ETC® Release Note

Eos®/ Ion™ Lighting Control Family Software

Version 1.4.5 software

Engineering Change Master (ECM): 500005164

Key-Cap Update

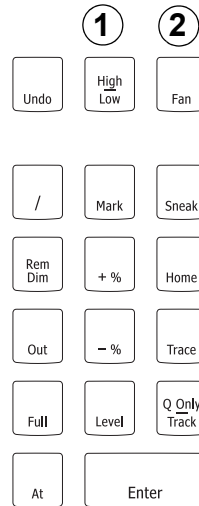
From Eos v1.3.1 to v1.4.x, two keys have been re-mapped and require that you change the physical keys on the console keyboard to match the software.

- Step 1: Use the key puller provided to remove the two keys shown below in the order indicated below.
- Step 2: Place the keys in their new correct locations and press them down firmly.
- “High/Low” replaces “Relate” and “Fan” replaces the blank key.

This is the correct final position for the keys.
“High/Low” replaces “Relate”.
“Fan” replaces blank.
